工程指示 / 要求簡箋 (E.I.)

工程指示編號：EI / 5527 / 23 (原 EI 5272) 修改版次：L  
 工程編號：J - 858 工程名稱：將軍澳日出康城 LP 11  
 工程項目：幕牆 大貨單元件加工圖 **防火棉** 以此為準  
 收件人：生統 / 王良 / 水洪 發件人：Ant Yeung 日期：20/02/2023

**Proposed Residential Development at TKOTL 70RP, Phase 11, Lohas Park,  
Tseung Kwan O, N.T., Site C2**

**Subject: Site Observation for Matter on Fire Isolation Installation and Other Issues at 12/F BD of T1**

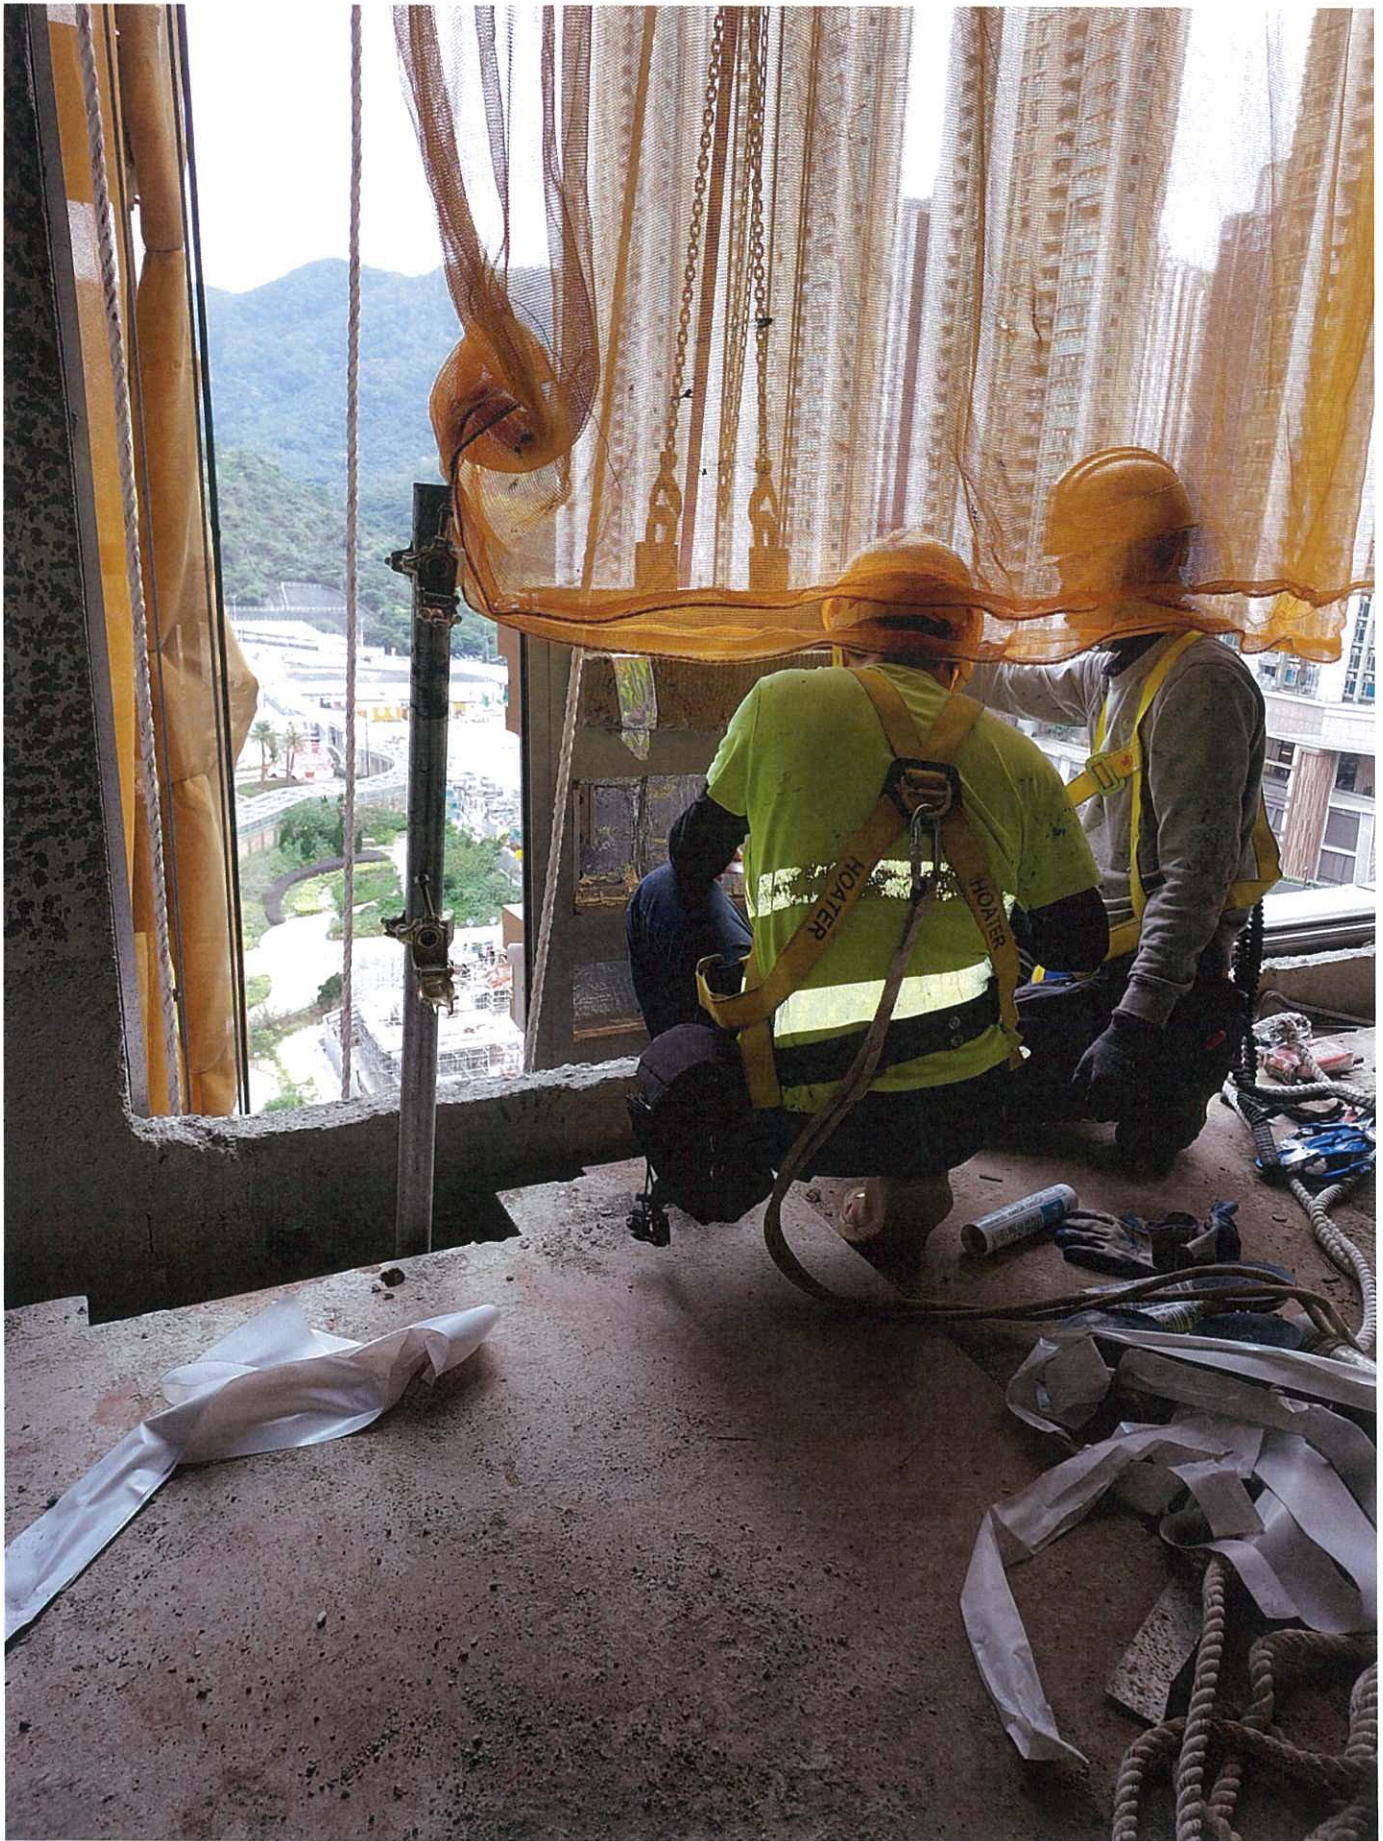
L 版：因應地盆安裝時，原本在地盆安裝的防火棉托，會阻礙安裝有飾線的單元件。

所以凡有飾線的單元件此防火棉需改由廠安裝。顧問已同意。(附報告)

\*請留意 防火棉需貼上錫紙，**錫紙包好完整，務不零去防火棉。**

↓ 需用锡纸包好  
完整

Photo 3

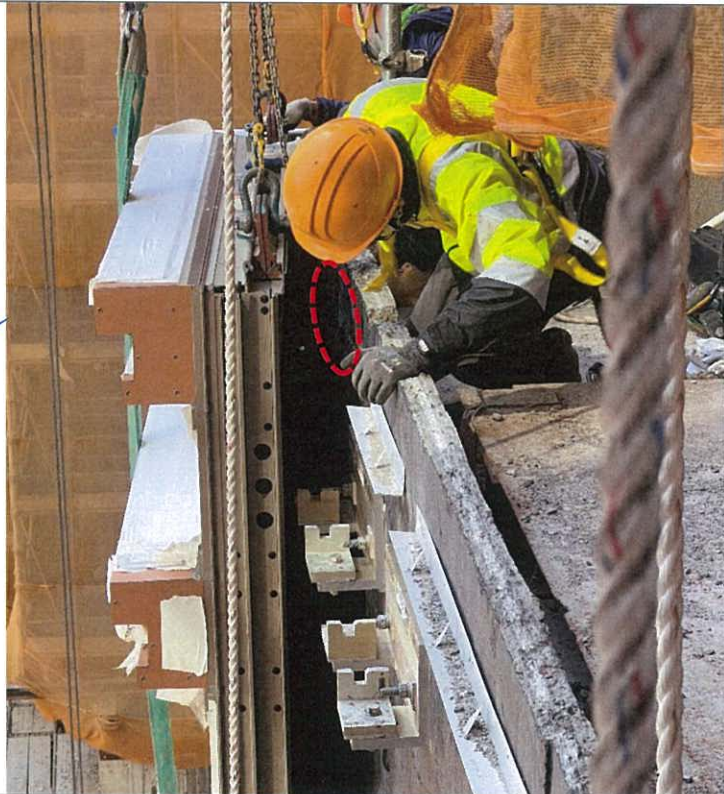
The retainer plate will clash with unit due to it limits unit movement for positioning.

Photo 4

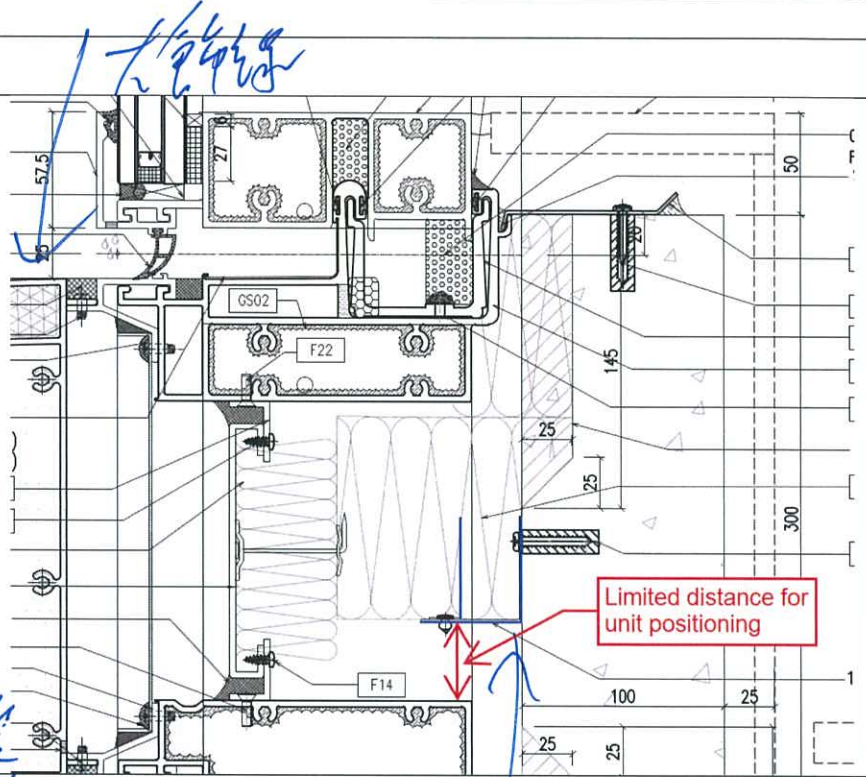
It was coordinated and agreed that the fire insulation was pre-mounted onto spandrel position for formal installation.

需用錫紙包好 (7/2 示範)  
(空包好, 不要跨士特)

**Photo 5**

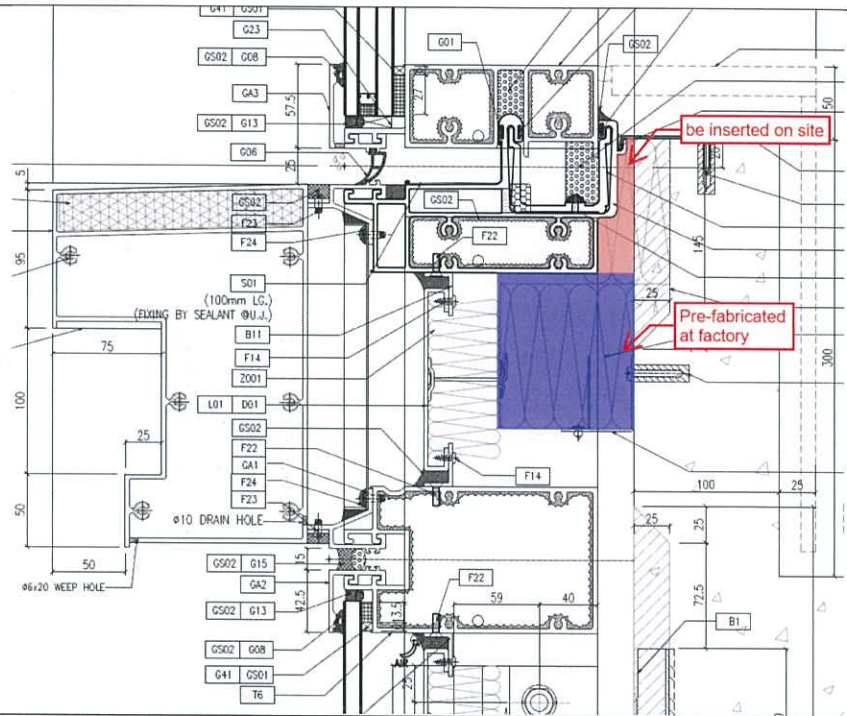
As per feedback from site, we recommend to pre-fabricate the fire insulation on to units at factory. And other parts of insulation can be inserted on site.

凡有能預製等元件  
在廠安裝更穩

**Photo 7**

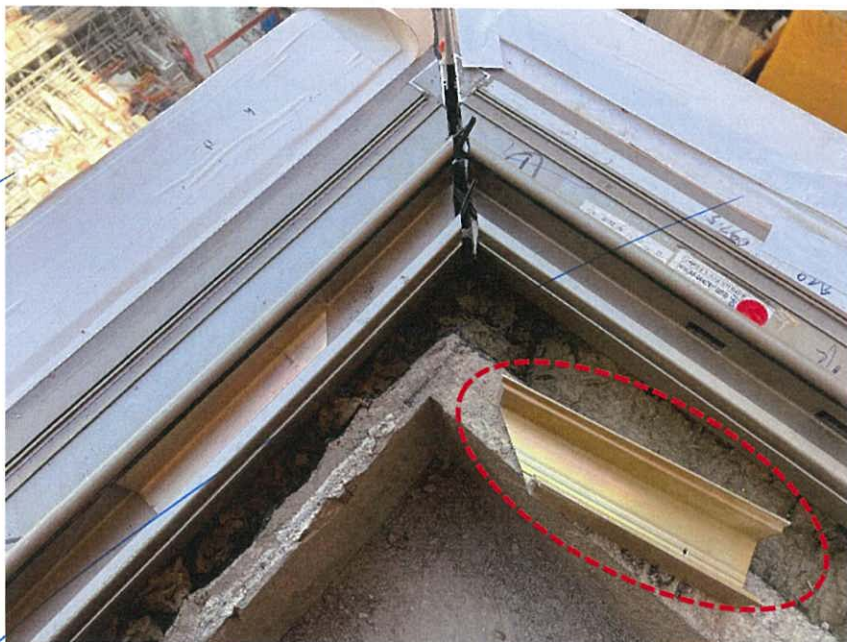
The installed retainer plate was observed to be with different orientation.

**Photo 8**

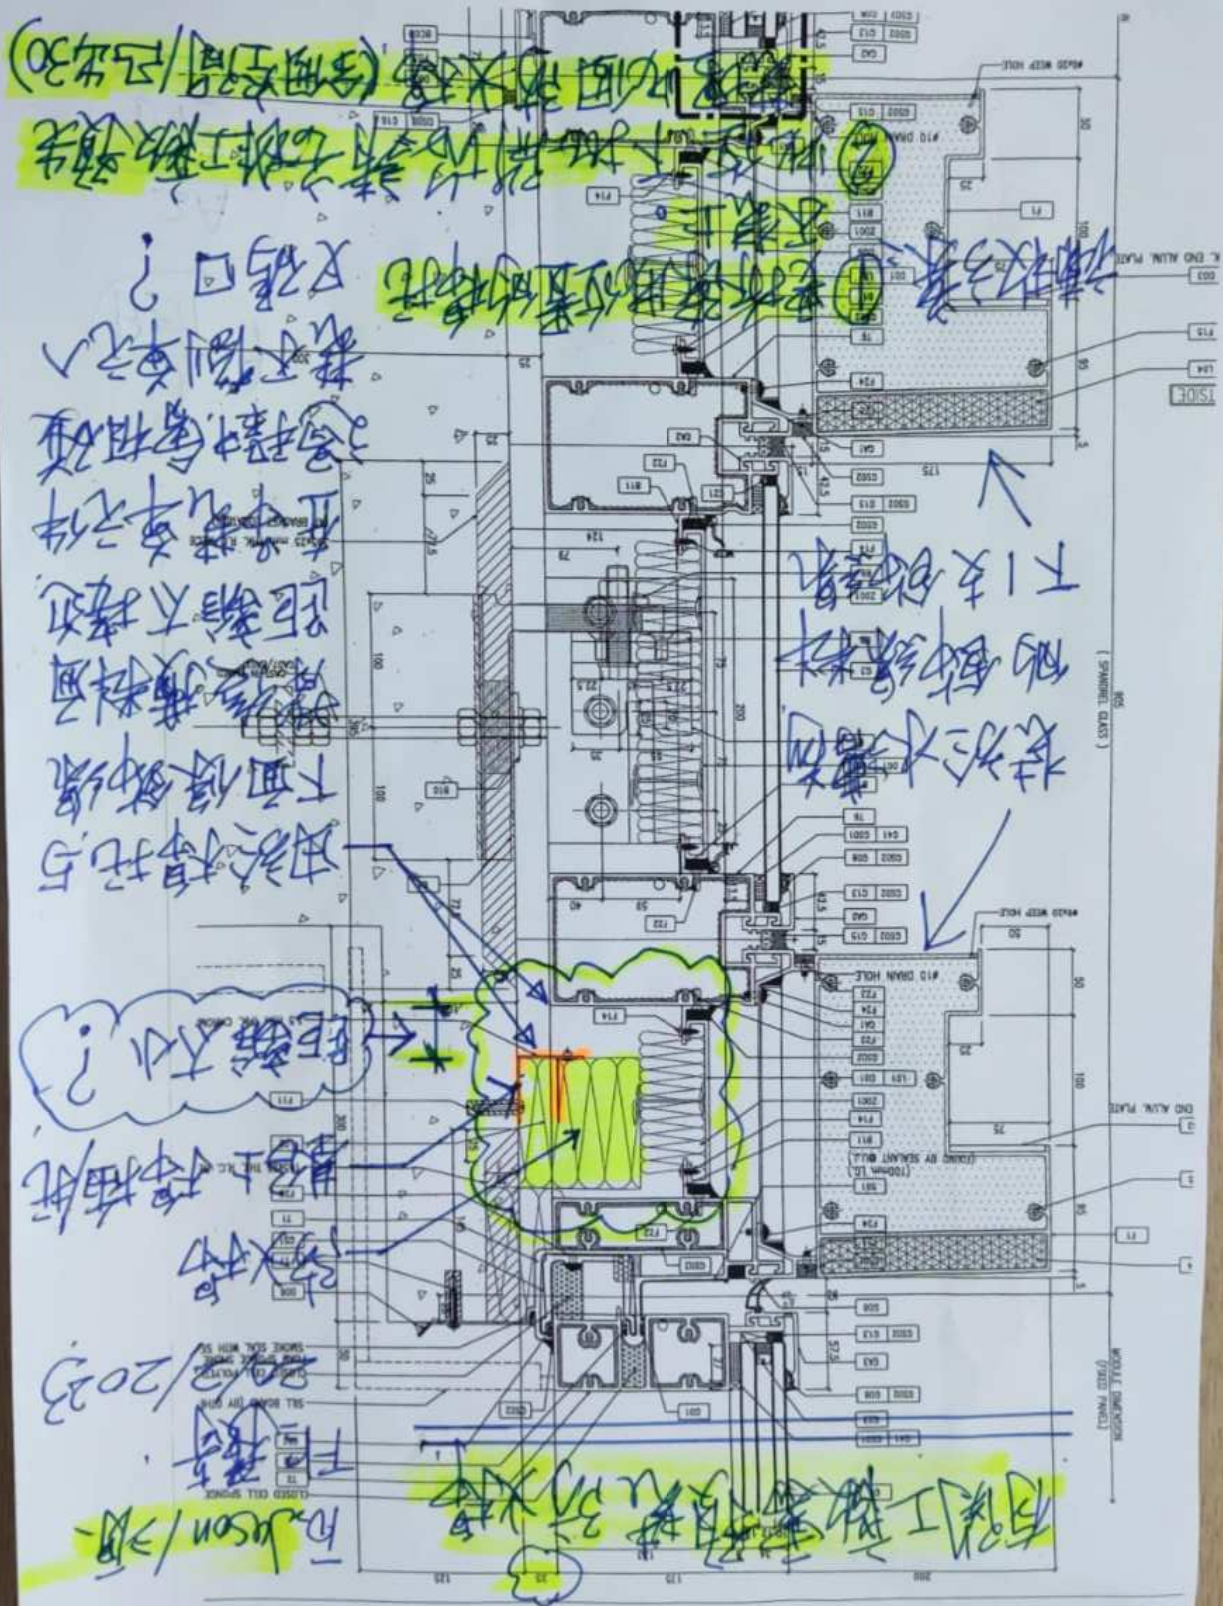
The RC curb was observed with damaged notch, please provide remedial for proposal its water proofing and fire rated performance.

此零件請工程師先  
確認此圖的結構 (參閱圖/24.30)

由於棉托與  
下面保飾線  
距離太接近  
導致橫料面  
距離不接近  
在裝車元件  
過程中會相碰  
甚至劇烈入

請收線  
更改線位置的棉托  
又碼口?
